## **Remarks**

**VI. Amendments to the Drawings and Specification**

**Amendments to the Drawings:**

FIG. 1

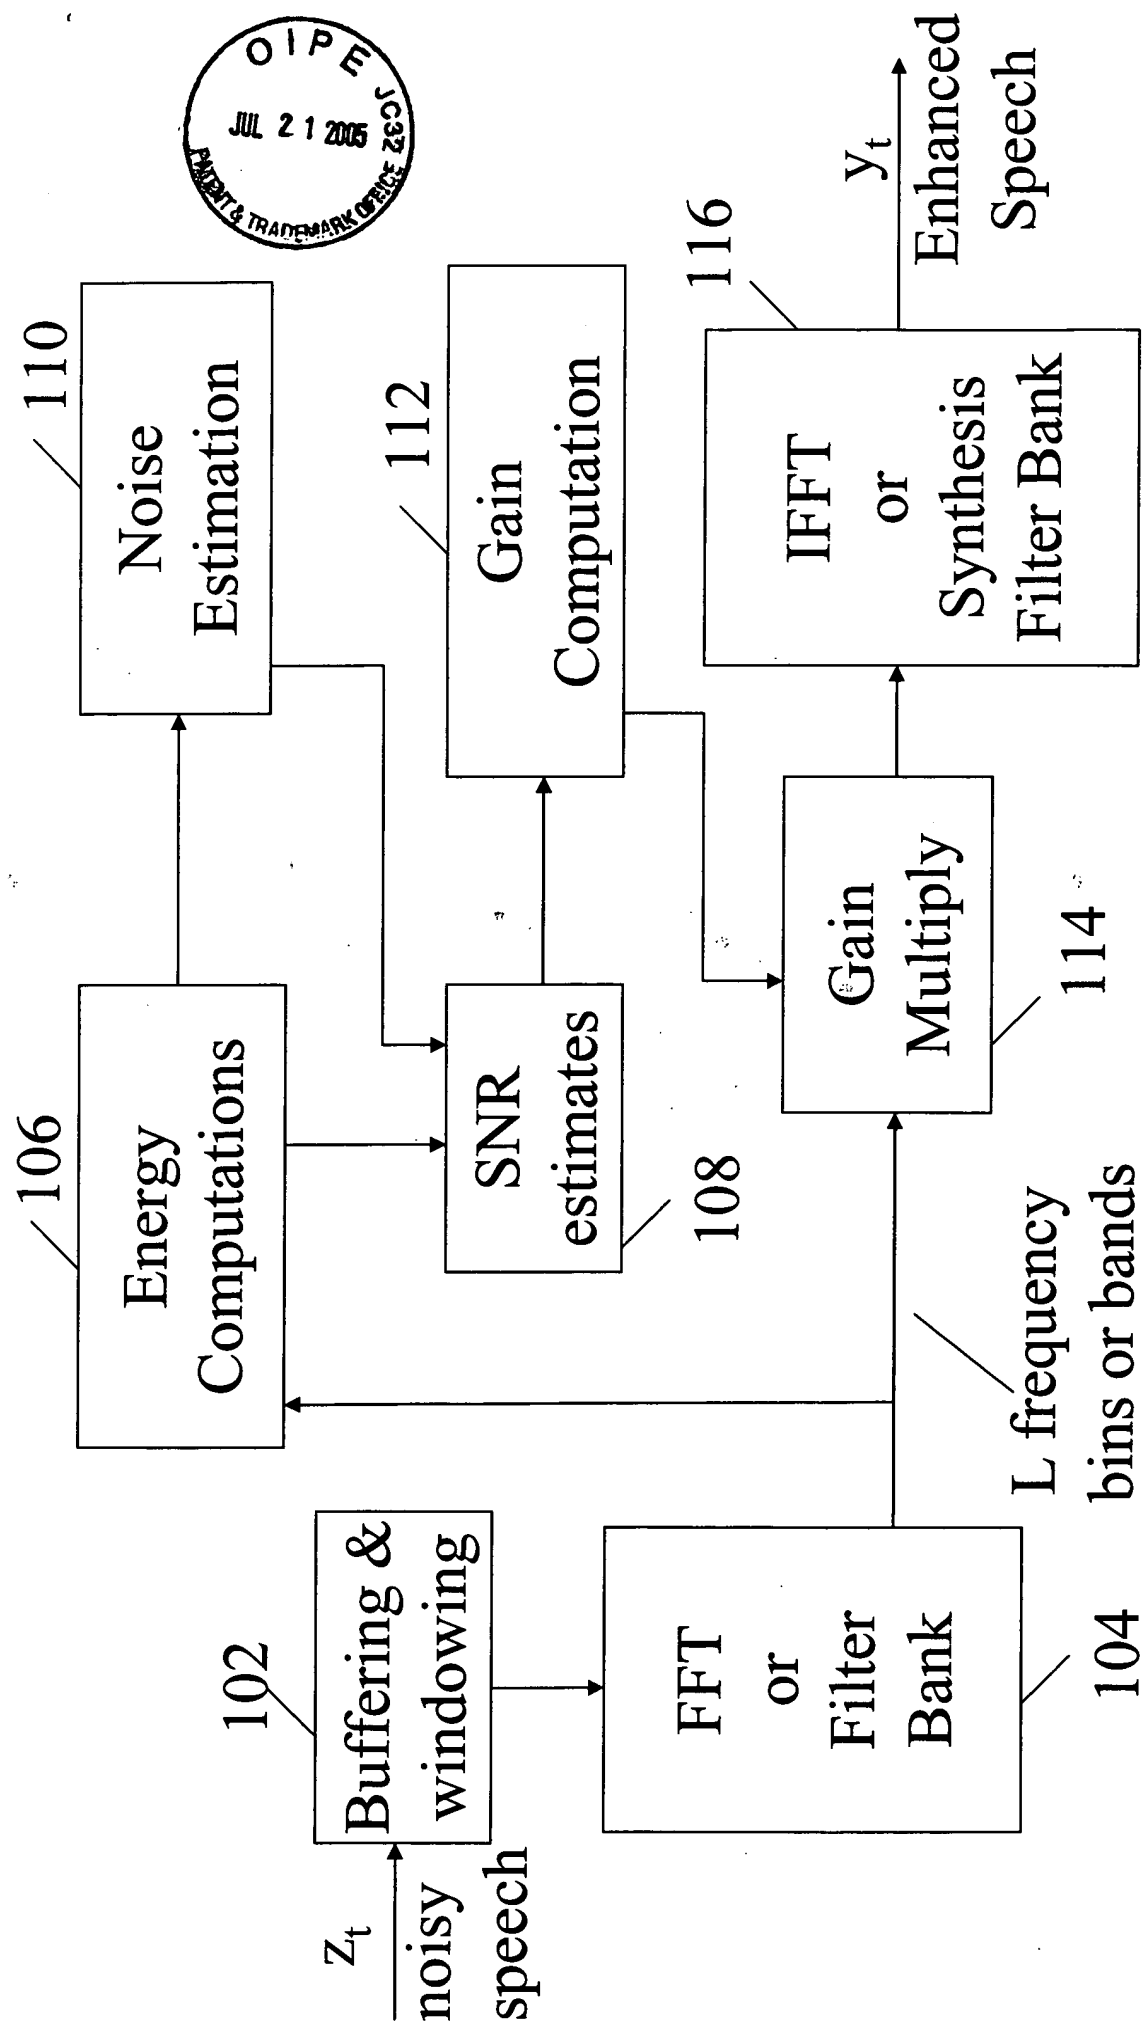
With respect to Figure 1, the Examiner stated that the recitation of "Related Art" should read "Prior Art" instead. In response, applicant has amended Figure 1 to read "Prior Art."

PRIOR  
~~RELATED~~ ART

FIG. 3

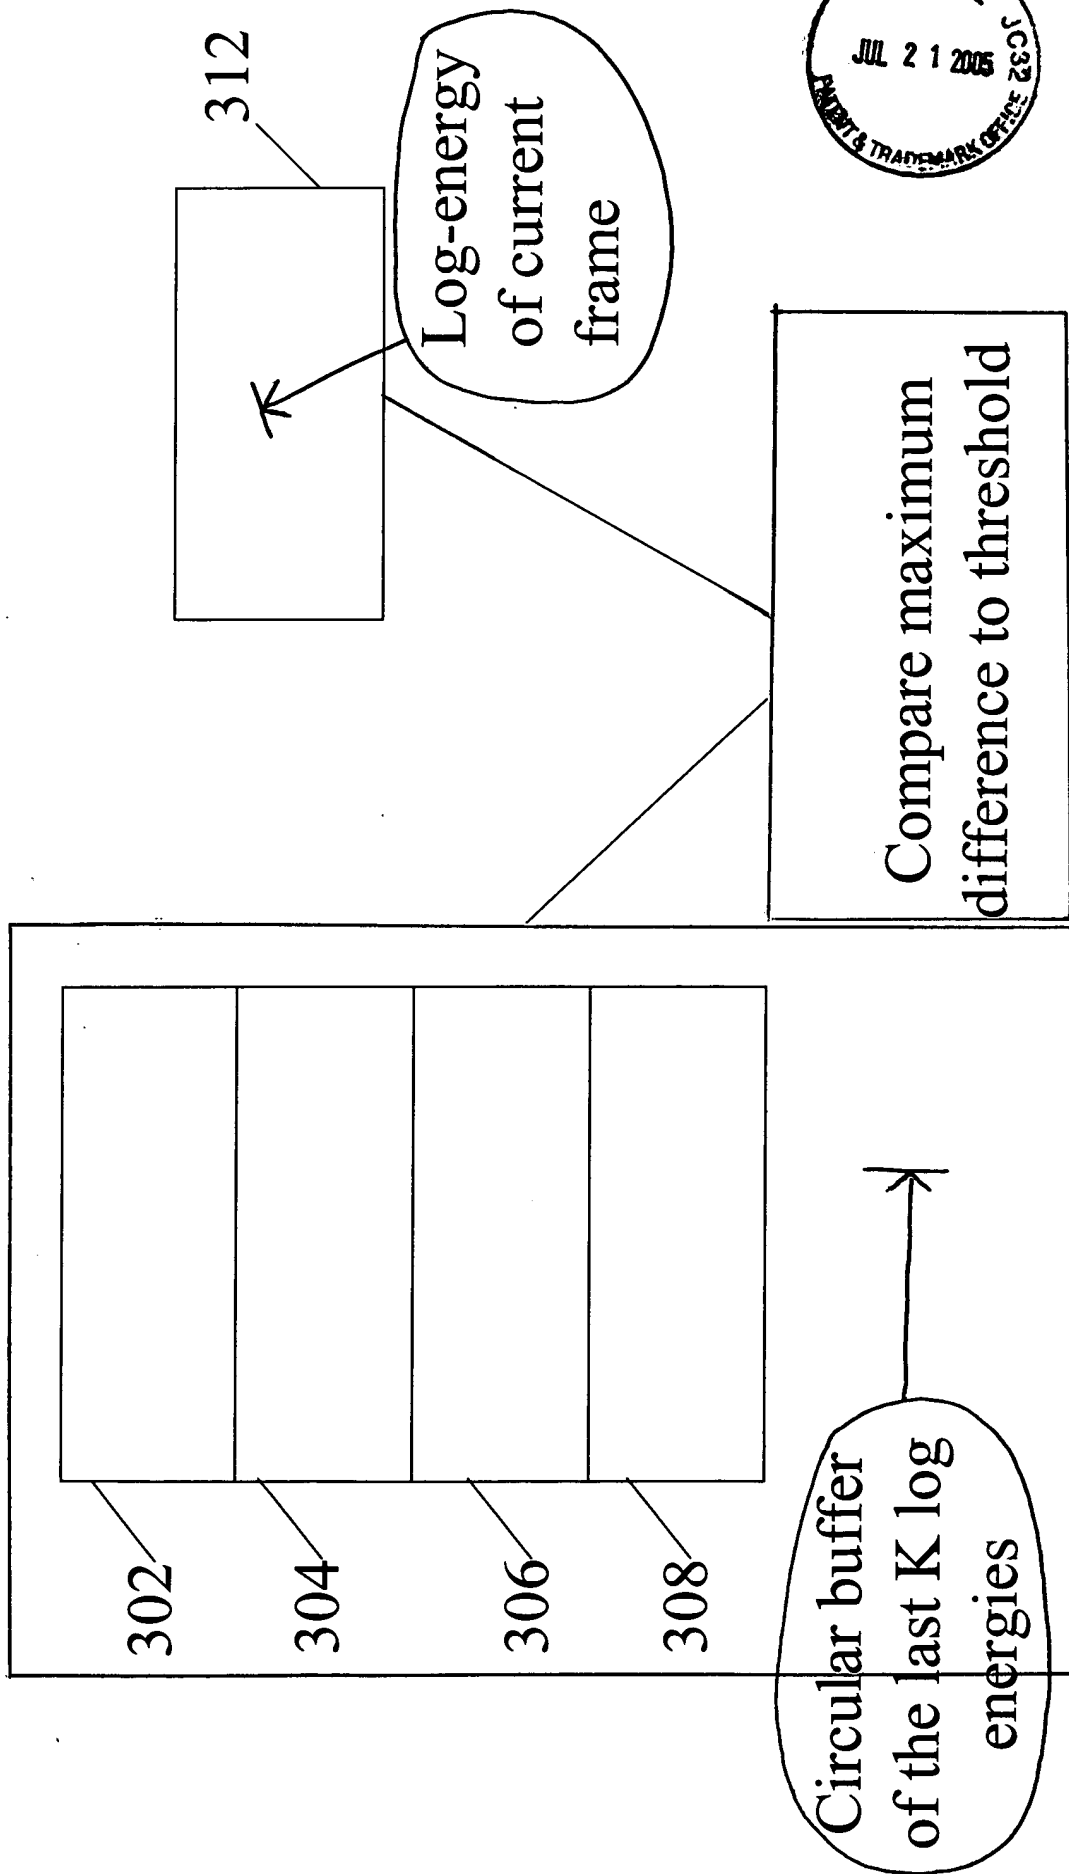
With respect to Figure 3, the Examiner noted that "[n]o reference is made in the specification to the blocks numbered in figure 3 nor do the blocks have descriptions or abbreviations inside them. The extraneous text of figure 3 should be placed in appropriate blocks or removed. It is unclear what relationship exists between blocks 302, 304, 306, 308 and 312 because no indication of data flow or input/output is evident. Two lines fail to interconnect or show direction of data flow between any elements of figure 3."

In response, applicant has amended the specification to make reference to blocks 302-312. Particularly, the specification has been amended to recite “[t]he difference of the log frame energy is equivalent to determining the ratio of the energy between the current frame 312 and each of the last K frames 302, 304, 306 and 308.” No new matter has been added. Additionally, applicant has amended Figure 3 to place the text inside appropriate boxes. The lead lines have been connected to these boxes to show that the maximum difference between energies 302-310 and 312 is compared to a threshold, as described in the corresponding description of Figure 3 in the specification (see p. 11, l. 15 to p. 12, l. 7 of applicant’s specification).

FIG. 5

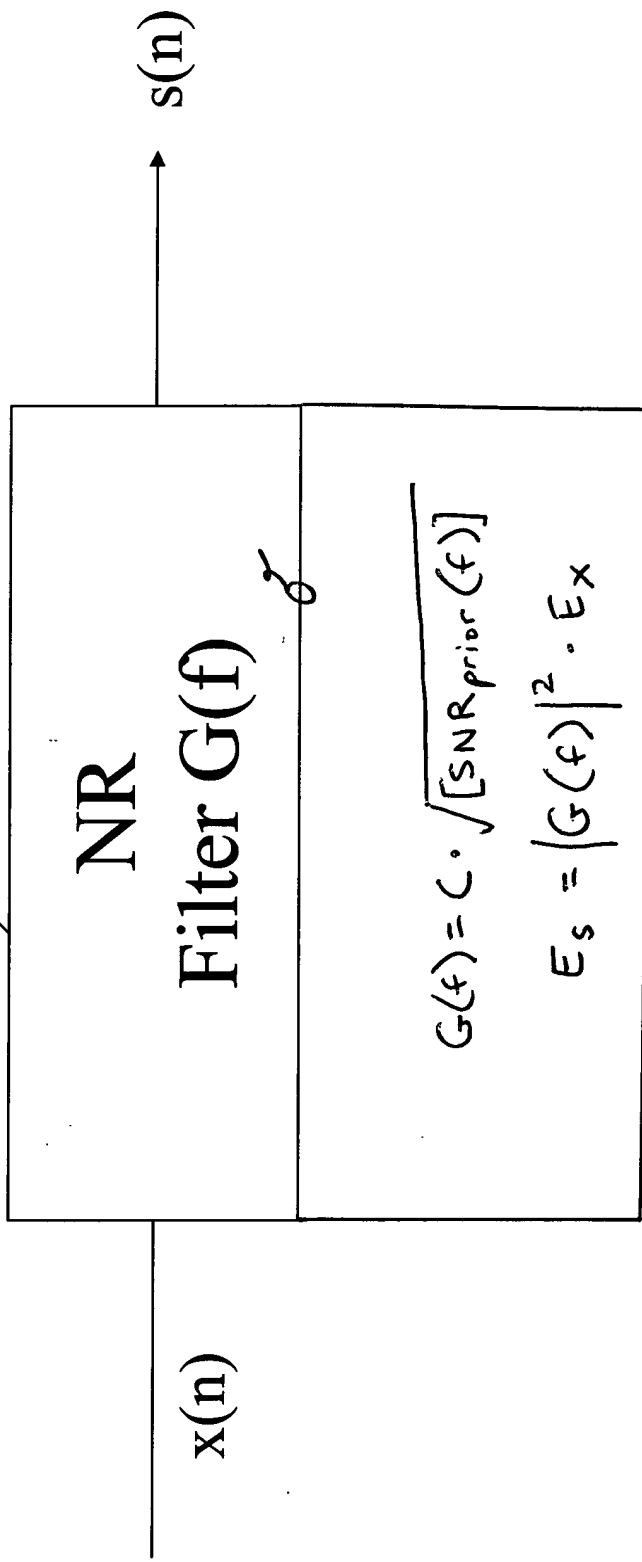
With respect to Figure 5, the Examiner stated that “Figure 5 is objected to as a ‘black box’ depiction which fails to show any meaningful processing. The details contained within block 502 should be shown to give this element significant meaning or the figure should be labeled as ‘prior art’.” In response, applicant has amended Figure 5 to show the description of the filter gain  $G(f)$  described in the specification (p. 18, ll. 1-9), and to show the relation described in the specification between the input and output energies of the speech bands as a function of the filter gain  $G(f)$  (p. 19, ll. 7-10).
